Date: October 6, 2006
 Refer to: EP2006-0887

SUBJECT: SUBMITTAL OF THE RESPONSE TO THE "NOTICE OF DISAPPROVAL FOR INVESTIGATION WORK PLAN FOR UPPER LOS ALAMOS CANYON AGGREGATE AREA"

**Response to the "Notice of Disapproval for
Investigation Work Plan for the Upper Los Alamos Canyon Aggregate Area,
Los Alamos National Laboratory EPA ID No: NM0890010515, HWB-LANL-06-012,"
Dated August 22, 2006**

Figure 3.2-1. SWMU 00-017 site map and proposed sampling locations

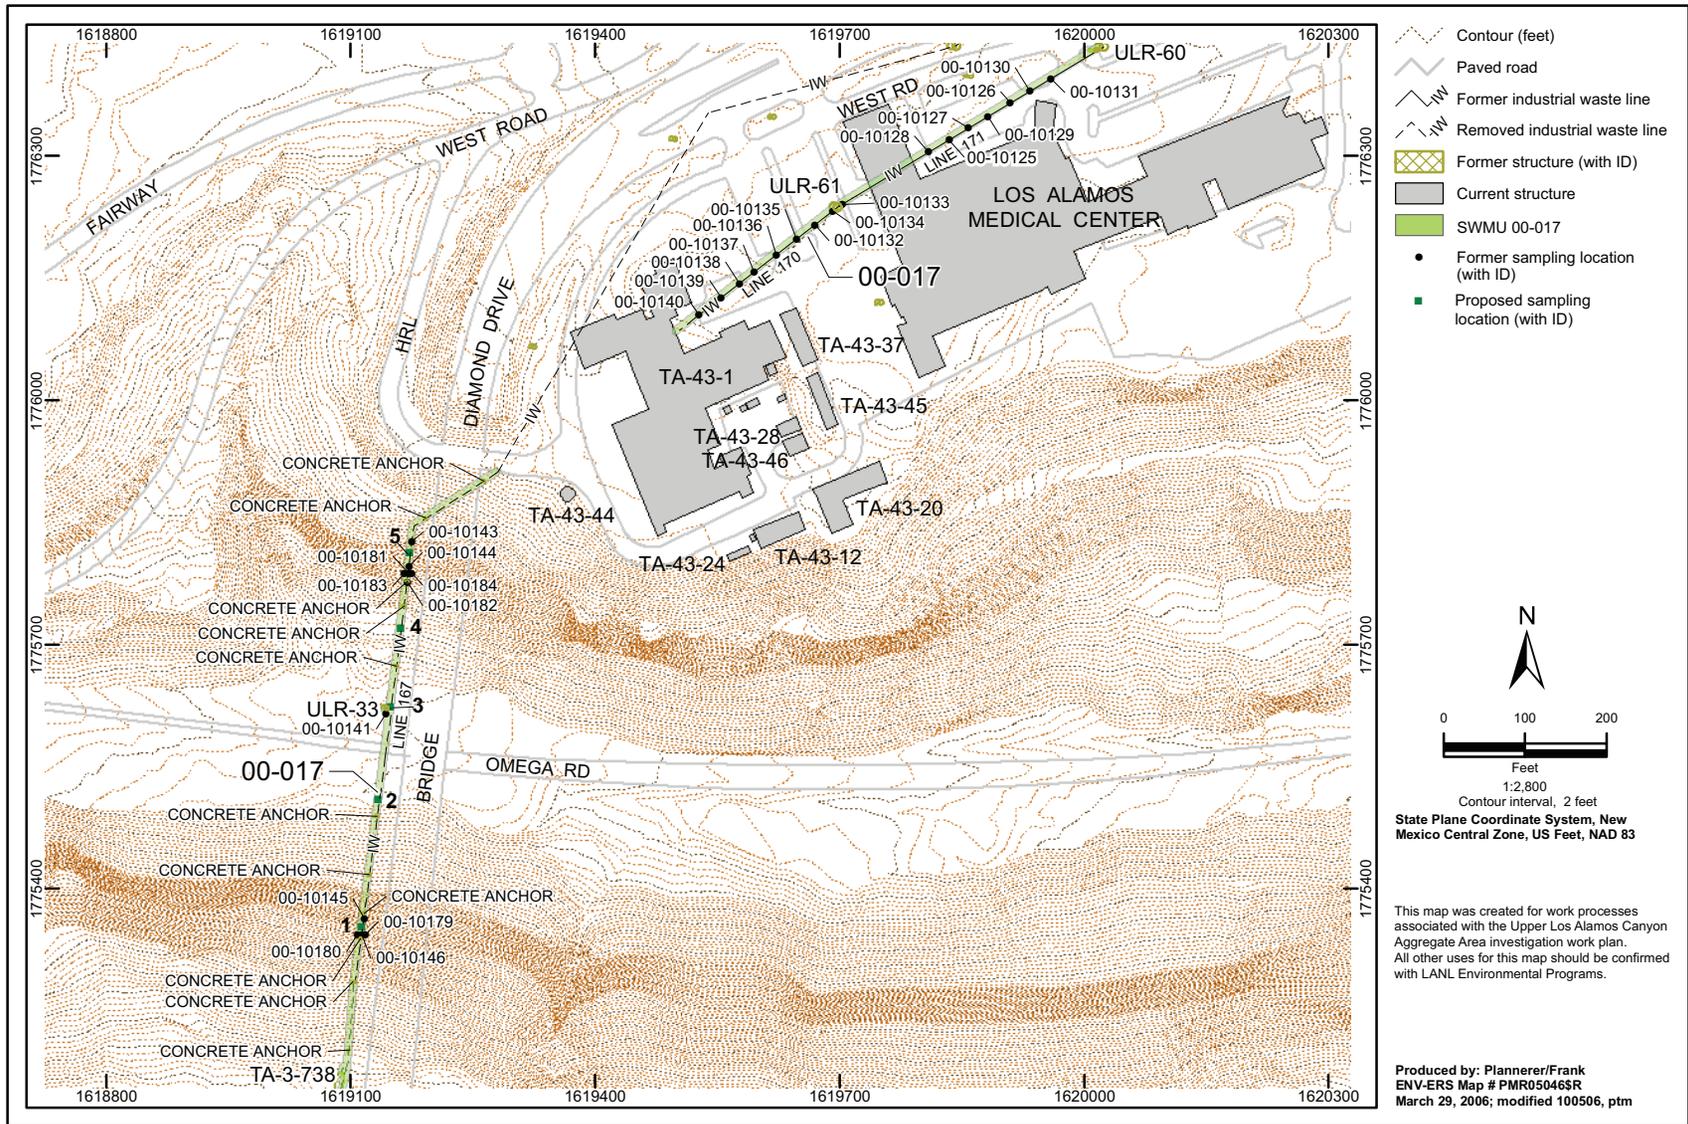
RFI report for SWMU 00-017 (LANL 1999, 64029) reports 45 samples from 29 locations were analyzed at off-site laboratory not 40 samples from 26 locations as reported in the WP. Resolve the discrepancy and revise the WP and HIR accordingly.

The revised work plan text follows, and the revised table (Table 3.1-1) and figure (Figure 3.2-1) are included in Attachments 2 and 3, respectively.

Samples analyzed at off-site fixed laboratories included 43 soil, fill, sediment, and tuff samples collected from 27 locations at SWMU 00-017 (Figure 3.2-1, Table 3.1-1). Samples from the 11 locations (00-10141, 00-10143 through 00-10146, and 00-10179 through 00-10184) at former line 167 were collected from depths of 0.1 to 9 ft. Samples from the 15 locations at line 170 and line 171 (00-10126 through 00-10140) were collected from depths of 12.5 to 27.5 ft, depending on the depth of the pipe. The suites analyzed for each sample are provided in Table 3.1-1.

PLATE 1 UPPER LOS ALAMOS AGGREGATE AREA

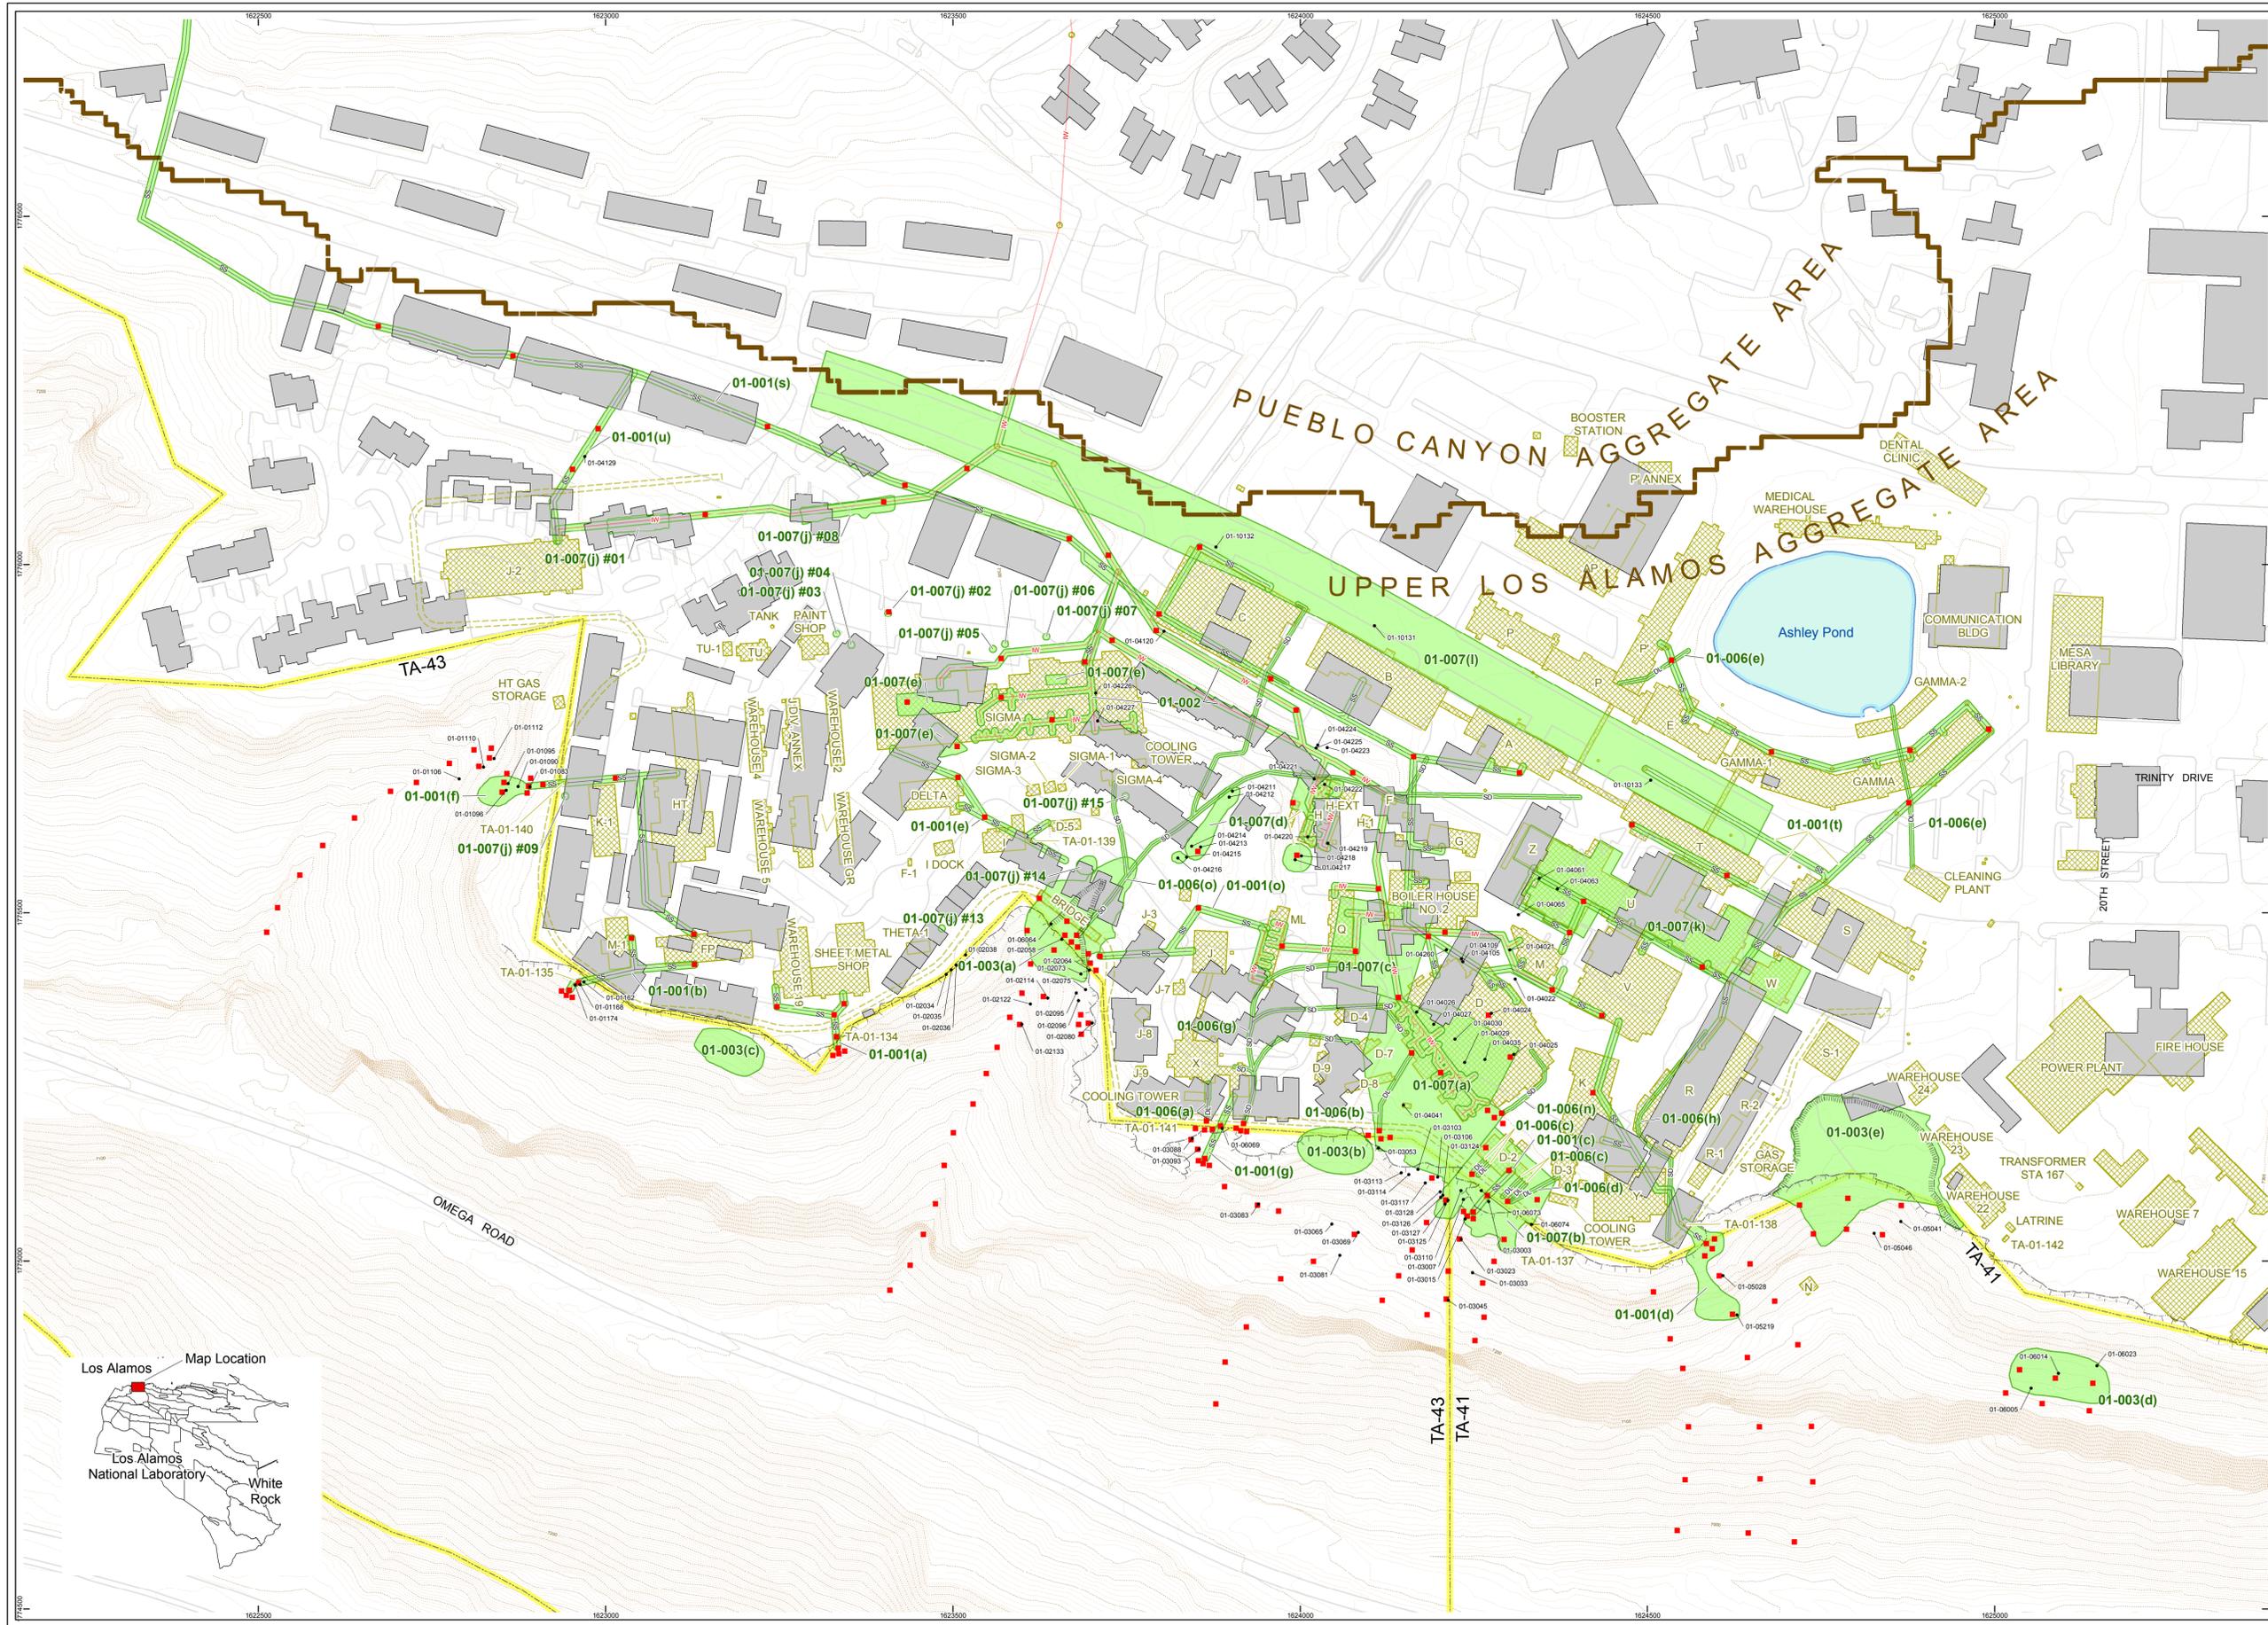
1. *To facilitate the review, please provide a map of Upper Los Alamos Aggregate area depicting existing and proposed sampling locations for the entire aggregate.*

1. The requested map of Upper Los Alamos Aggregate Area depicting previous and proposed sampling locations for the entire aggregate is provided as Plate 1. For clarity, a map showing the former and proposed sampling locations for Technical Area (TA) 01 is also provided (Plate 2).
